**HUMBOLDT COUNTY
DEPARTMENT OF PUBLIC WORKS
CONTRACT CHANGE ORDER MEMORANDUM**

TO: Thomas K. Mattson Public Works Director			FILE: PROJECT NAME: Mattole Road (F3C010) at PM 5.00 Storm Damage Project	
FROM: Chuck Dory, P.E. Resident Engineer			Contract No.: 217224 Caltrans EA.: None Federal No.: ER-32L0(118)	
CCO NO. 2	SUPPLEMENT NO.	CATEGORY CODE	CHOOSE ONE: <input checked="" type="checkbox"/> CONTINGENCY WORK OR <input type="checkbox"/> SUPPLEMENTAL WORK	
CCO AMOUNT \$291,976.05 INCREASE <input checked="" type="checkbox"/> DECREASE <input type="checkbox"/>			CONTINGENCY BUDGET: \$96,650.00	SUPPLEMENTAL BUDGET: \$0.00
			CONTINGENCY BALANCE (including this change): (-)\$286,951.05	SUPPLEMENTAL BALANCE (including this change): \$0.00
HEADQUARTERS APPROVAL REQUIRED? YES <input type="checkbox"/> NO <input checked="" type="checkbox"/>			ORIGINAL CONTRACT AMOUNT: \$965,167.00	
BOS APPROVAL REQUIRED? (if > Contingency) YES <input checked="" type="checkbox"/> NO <input type="checkbox"/>			CUMULATIVE ENCUMBRANCE OF ALL CONTINGENCY CONTRACT CHANGE ORDERS (including this change): \$383,601.05	CONTINGENCY CONTRACT CHANGE ORDERS AS A % OF ORIGINAL CONTINGENCY AMOUNT (including this change):

COUNTY OF HUMBOLDT DEPARTMENT OF PUBLIC WORKS	SHEET 13 OF 26
STORM DAMAGE REPAIR MATTOLE ROAD PM 5.00 & 13.67	
PM 5.00 RETAINING WALL LAYOUT No. 2

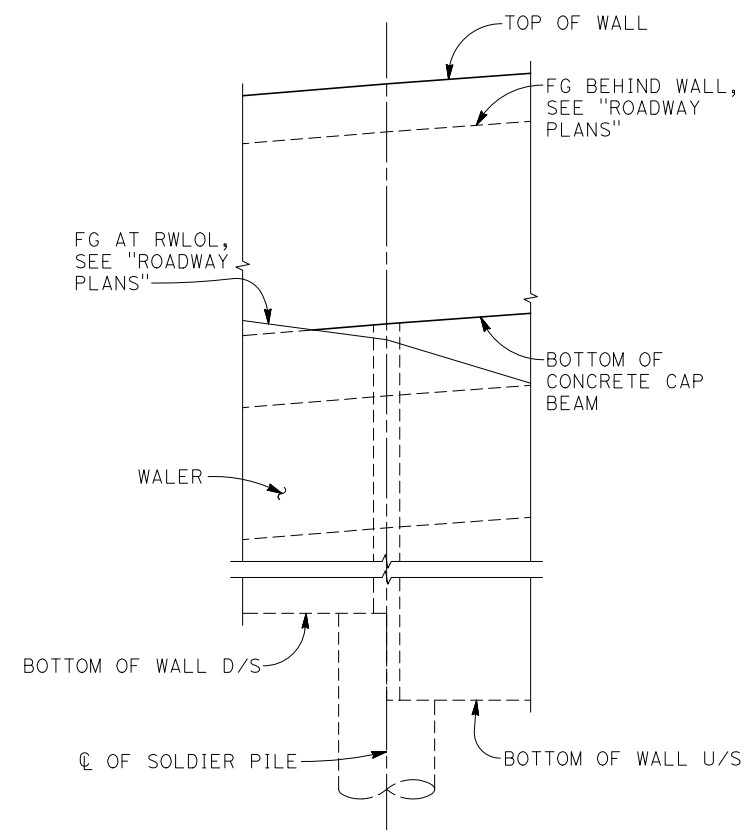
- NOTES:
- Top of Wall elevations shown are based on "ROADWAY PLANS", verify elevations with "ROADWAY PLANS" prior to construction. Notify Engineer if top of wall elevations are higher than shown on plans.
 - Per the Geotechnical report by Crawford & Associates, Inc., dated April 2019, the ground anchor unbonded length shall extend at least 5 feet or H/5, whichever is greater (H = wall Height), beyond the "intact" material.
 - Abandon TYPE "B" ANCHORS. Remove nut on threaded bar to fully de-stress the anchors. Install anchorage enclosure and grout.
 - Where the anchor bond spacing is 4 foot or less, a strength reduction factor (to be determined by the contractor) shall be applied to the bond strength of the individual ground anchors to account for anchor load-transfer interaction.

GROUND ANCHOR TYPE	FACTORED DESIGN LOAD, FDL (kips)	MINIMUM UNBONDED LENGTH (FT) SEE NOTE 2
(B)	SEE NOTE 3	SEE NOTE 3
(C)	185	26'-0"
(D)	145 SEE NOTE 4	26'-0"

4. Calculations for determining the bonded length. Do not rely on any capacity from the grout-to-ground bond within the unbonded length. Do not rely on any capacity from the Type B ground anchors.

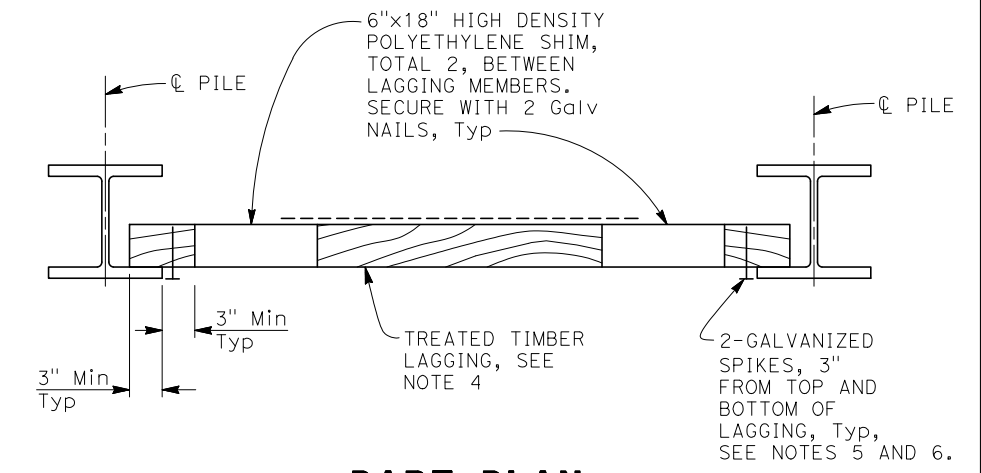
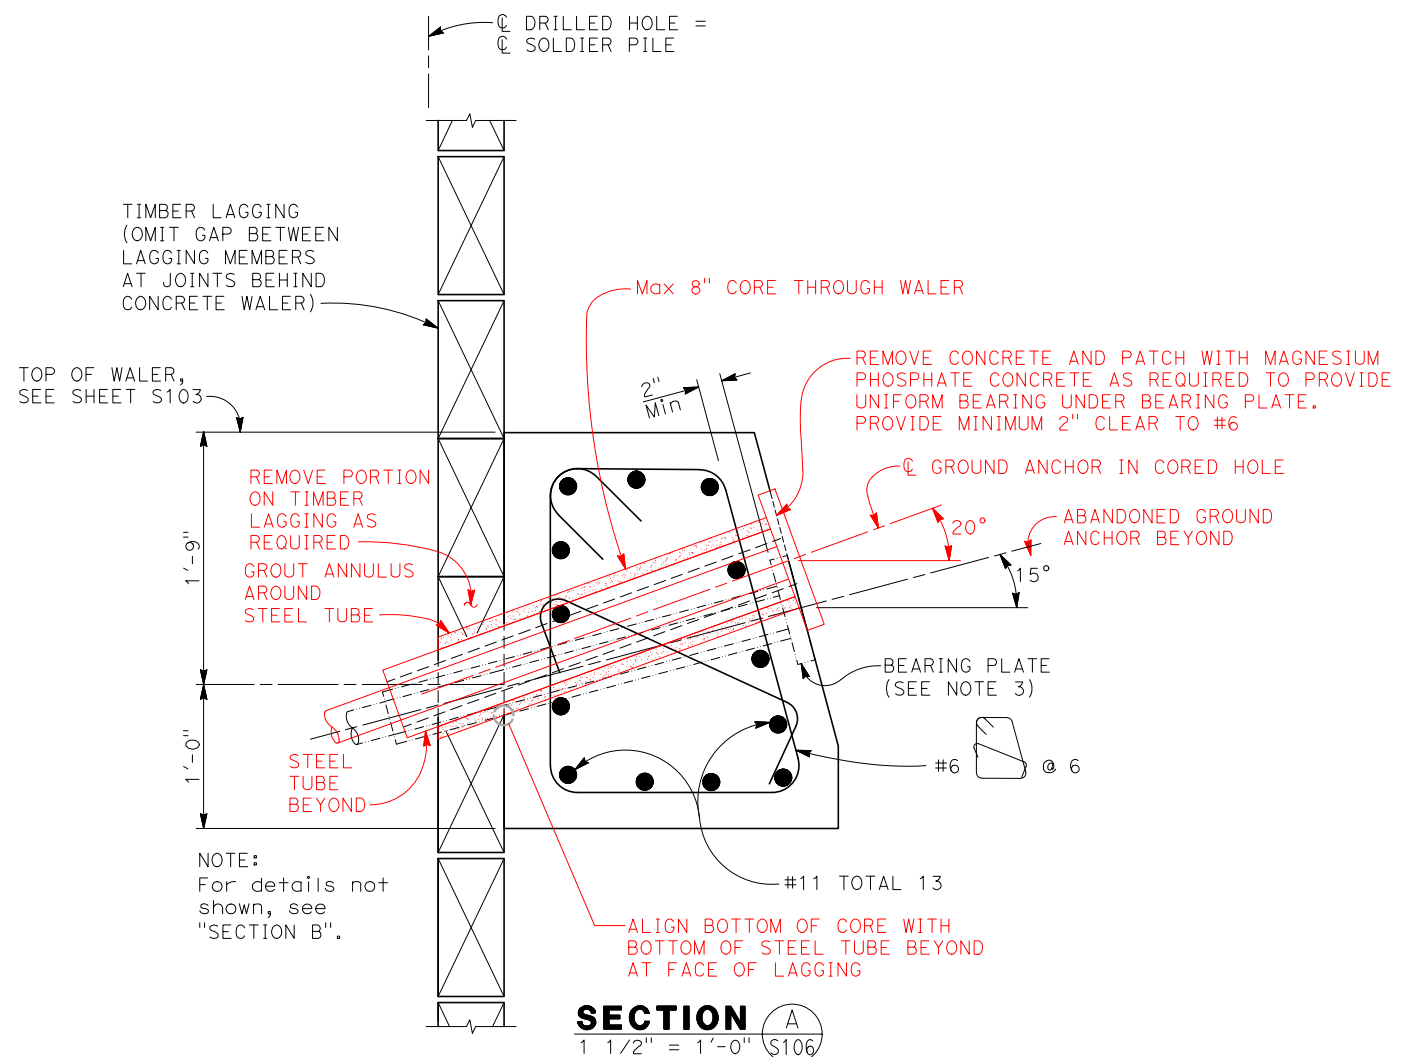
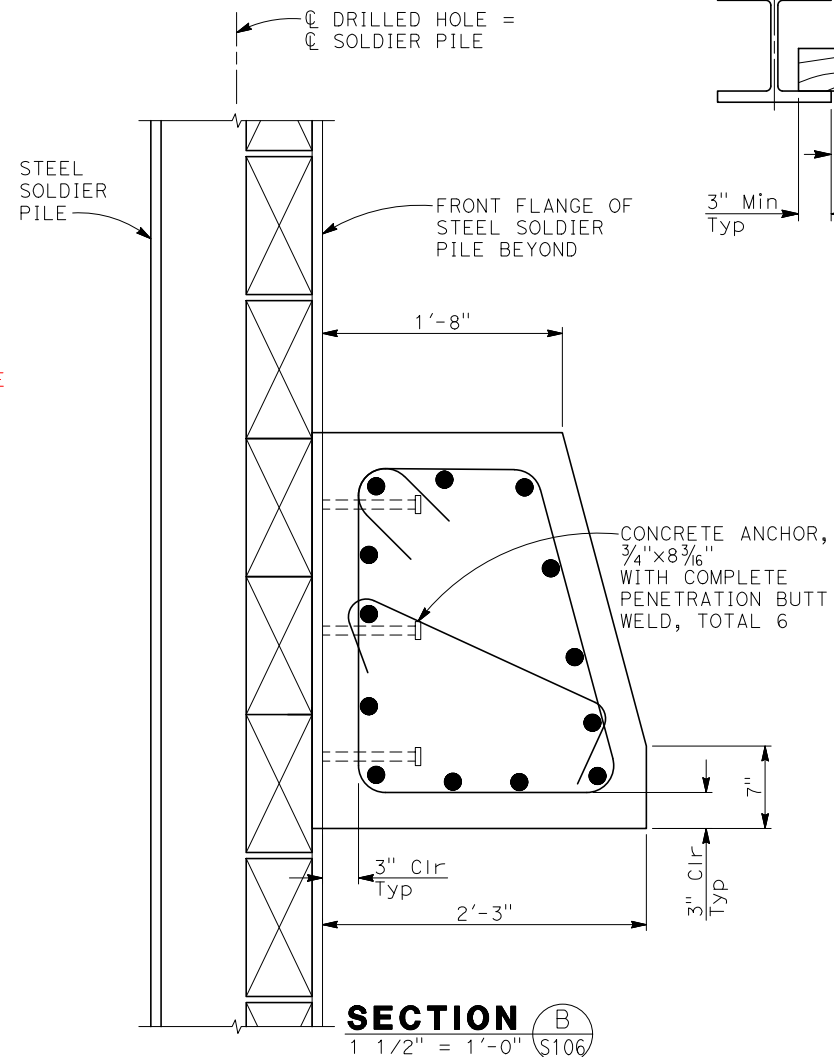
- NOTES:
1. For concrete waler location, see "SOLDIER PILE WALL SECTION" shown on "SOLDIER PILE WALL DETAILS" sheet.
 2. Concrete walers may be poured to face of lagging.
 3. Bearing plates may be recessed or on face of concrete waler.
 4. No clipping of timber lagging corners allowed.
 5. Use 40d Galv wire spikes for 6x12 lagging.
 6. Spikes shall not be bent.
 7. Place stirrups 1/2" clear of anchorage tube.
 8. Prior to coring, locate existing stirrups by GPR scanning or similar method. Relocate core horizontally maximum 2" so core will only cut one #6 stirrup.

46-1.03F Coring

Cores through the existing waler must conform to section 60-4.04. Select a core diameter that provides adequate clearance for drilling and a minimum 1 inch clear space around the steel tube.

Prior to coring, locate existing reinforcement and determine location of core as shown.

Prior to inserting the tendon, clean loose and foreign material from cores and flush cored holes with water.

Fully grout the space around the steel tube.

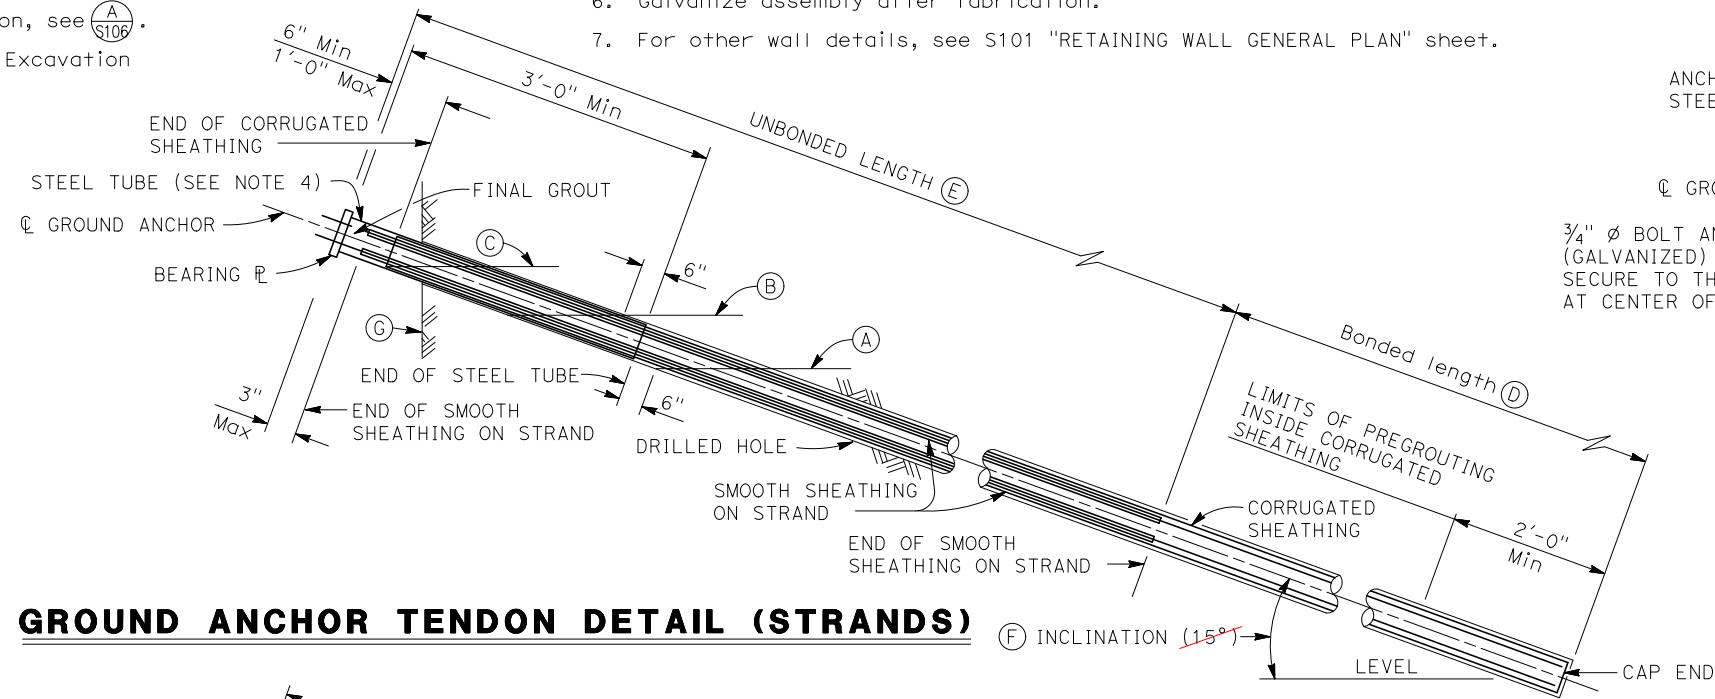
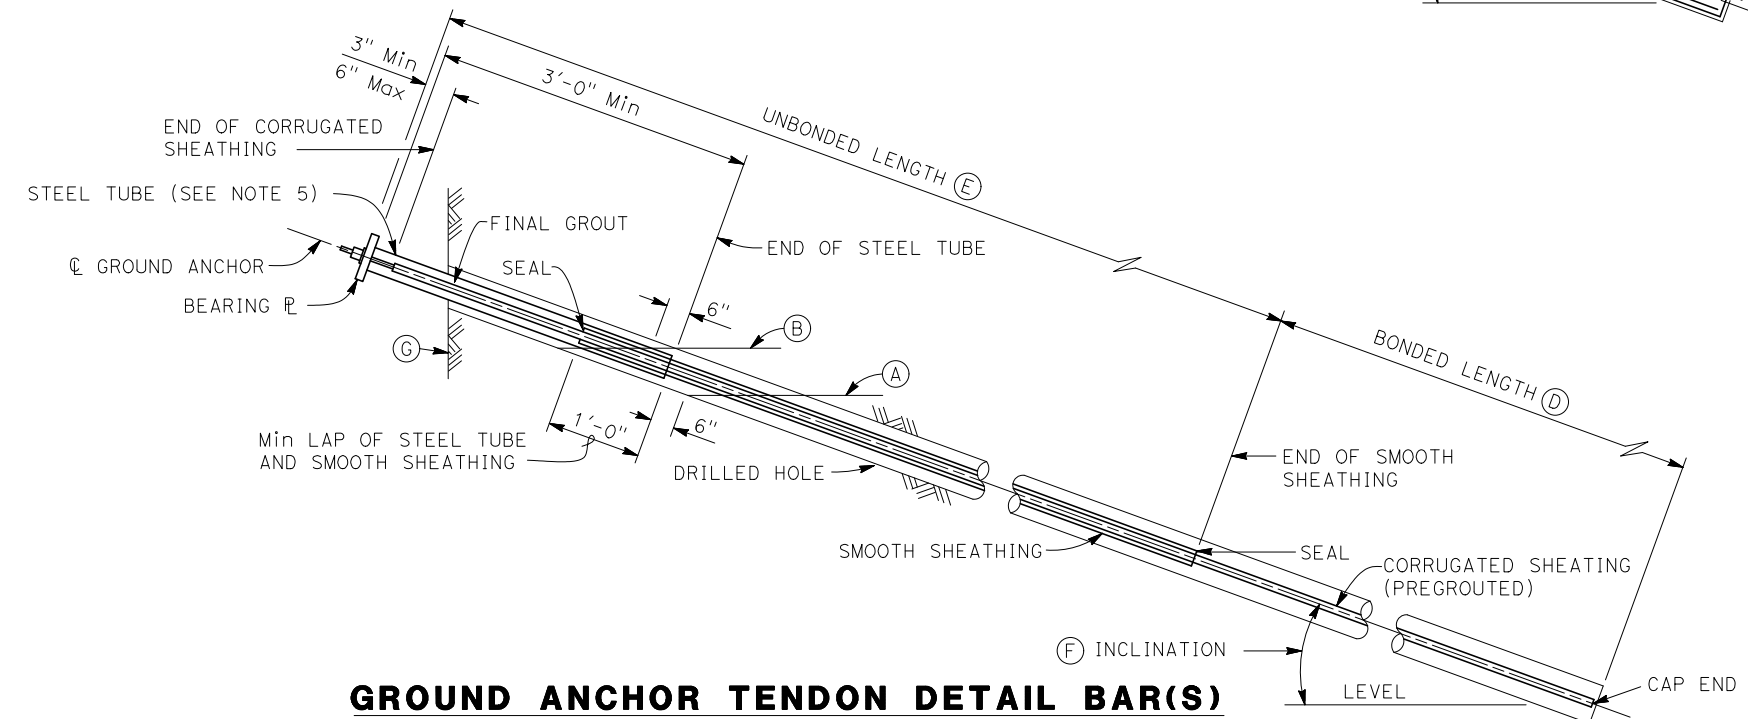
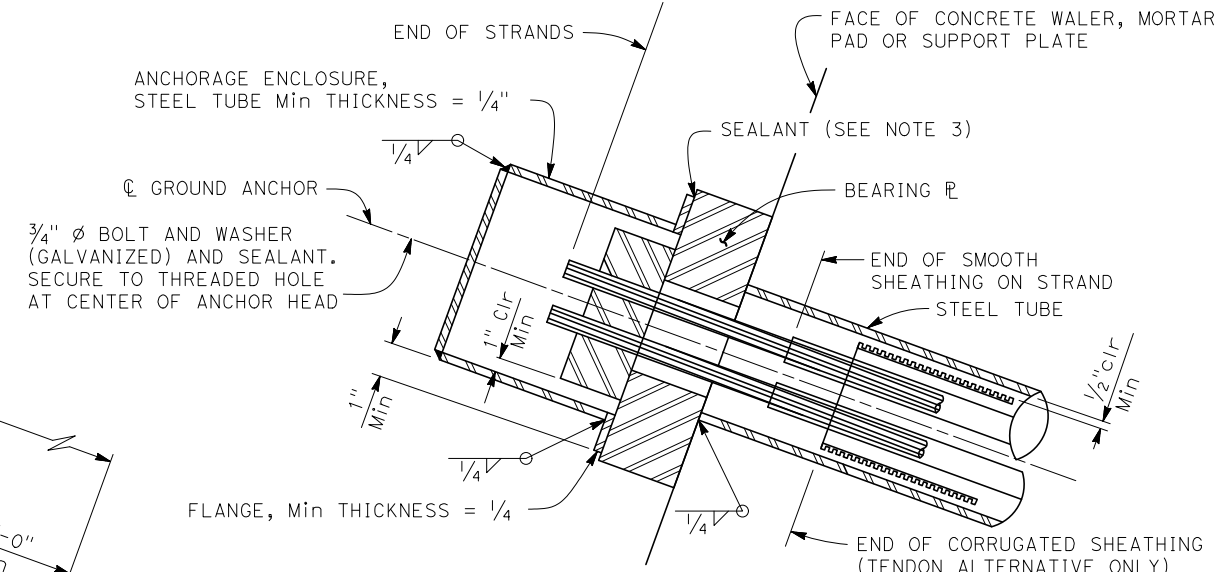
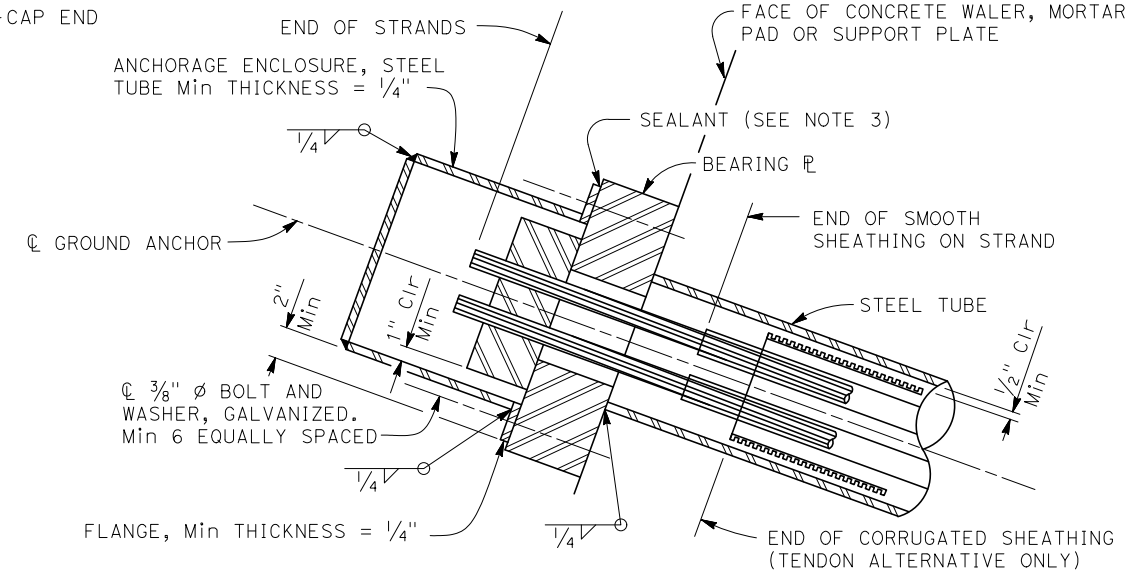
- (A) Level of initial grouting for drilled hole 6" in diameter or smaller
- (B) Level of secondary grouting
- (C) Level of initial grouting inside corrugated sheathing
- (D) Bonded length shall be determined by the contractor
- (E) For unbonded length, see "RETAINING WALL LAYOUT No. 2"
- (F) For inclination, see (A/S107).
- (G) Face of Wall Excavation

1. Anchorage enclosure shall only be used when anchor head assembly is not enclosed in concrete.
2. Anchorage enclosure shall have provisions to allow injecting grout at low end and venting at high end. Galvanize after fabrication.
3. Silicone sealant to cover full width of flange.
4. Steel tube (Min thickness = 1/4") welded to bearing plate. Galvanize assembly after fabrication
5. Steel tube welded to bearing plate. Inside diameter of steel tube (Min thickness = 1/4") to be 1" greater than outside diameter of smooth sheathing.
6. Galvanize assembly after fabrication.
7. For other wall details, see S101 "RETAINING WALL GENERAL PLAN" sheet.

Install tubes to facilitate post-grouting of all ground anchors.

The permanent bearing plate must effectively distribute the factored test load uniformly to the concrete such that:

1. In your design calculations, the area of the cored hole is treated as an open hole and does not provide any bearing support
2. Concrete bearing stress does not exceed 2,400 psi
3. Bending stress of the plate does not exceed:
 - 2.1. 0.90 of the yield strength for steel
 - 2.2. 0.55 of the yield strength for cast steel or cast iron
